SUBJECT: R.E. GINNA NUCLEAR POWER PLANT – CORRECTION TO AMENDMENT NO. 116 ISSUED AUGUST 12, 2014, RE: REVISION TO TECHNICAL SPECIFICATION SECTION 3.6.5, “CONTAINMENT AIR TEMPERATURE.” (TAC NO. MF0900)

LICENSE AMENDMENT NO. 116,
DATED AUGUST 12, 2014
(NON-PROPRIETARY)

SUBJECT: R.E. GINNA NUCLEAR POWER PLANT - ISSUANCE OF AMENDMENT RE:
REVISION TO TECHNICAL SPECIFICATION SECTION 3.6.5, "CONTAINMENT
AIR TEMPERATURE." (TAC NO. MF0900)

SAFETY EVALUATION BY THE OFFICE OF NUCLEAR REACTOR REGULATION

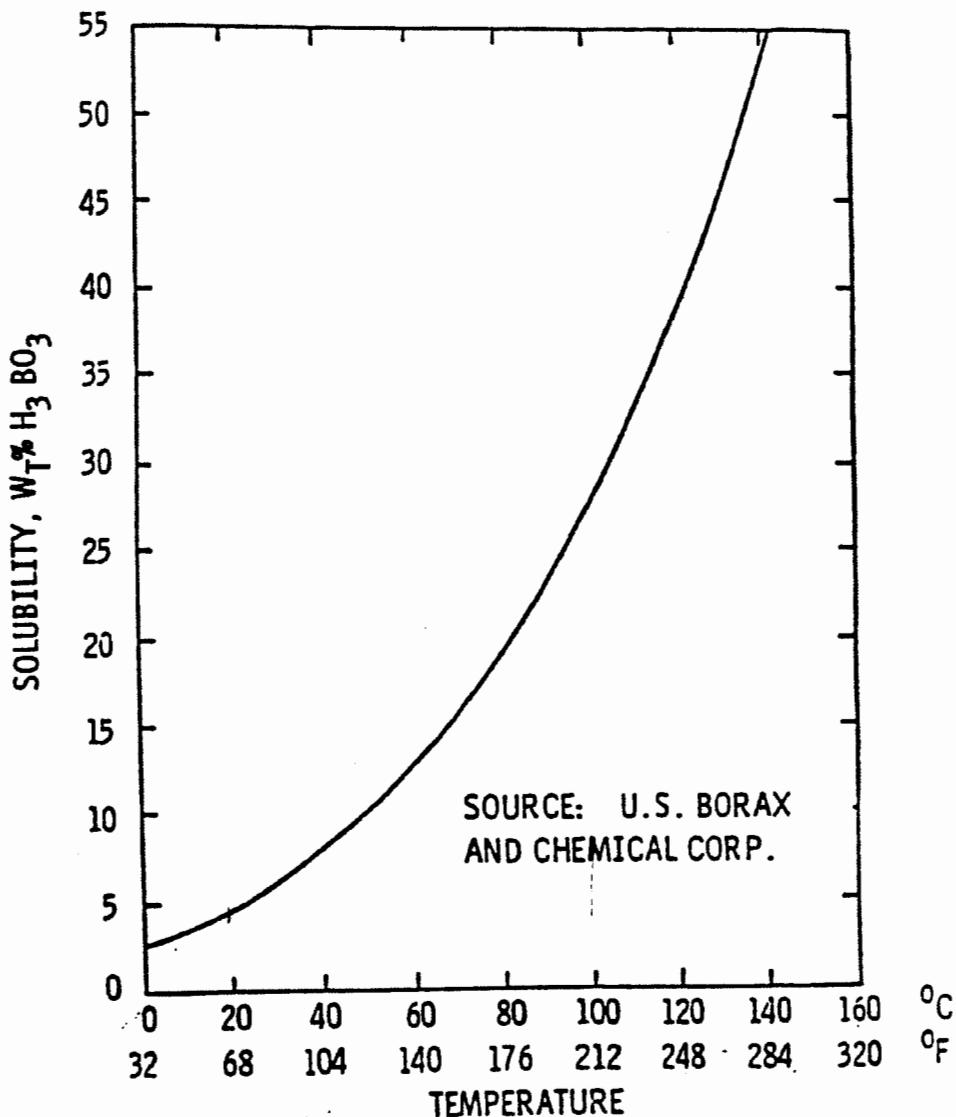
For break sizes 4-inches and larger, accumulator injection is required to prevent the core from becoming uncovered. In these cases, the accumulator flow rate is the dominating factor in the analyses. The amount of water entering the RCS to fill the downcomer and core and mixing with the cold leg fluid that is much hotter outweighs the 5 °F increase in accumulator temperature. This leaves the 2-inch break size as the limiting case.

For the 3-inch break size where accumulator injection occurs only 75 seconds before PCT, core recovery depends on the timing of accumulator injection. If the accumulator temperature increases, fuel temperatures increase for a longer period of time once SI injection occurs. This will ultimately cause PCT to increase. The PCT for a break size of 3 inches is 1117 °F. There is a 50 °F margin between this case and the limiting PCT of 1167 °F for the 2-inch break. The result of a 5 °F increase in accumulator temperature will have a negligible impact on PCT when compared to the 50 °F margin to the limiting PCT for this case. This is because, similar to break sizes of 4-inches and larger, the amount of mass entering the system and mixing with the cold leg fluid that is much hotter outweighs a 5 °F increase in accumulator temperature.

The licensee concludes that the PCT for an SBLOCA remains 1167 °F for a break size of 2 inches. Based on the above discussion, the NRC staff finds the results of the licensee's analysis acceptable.
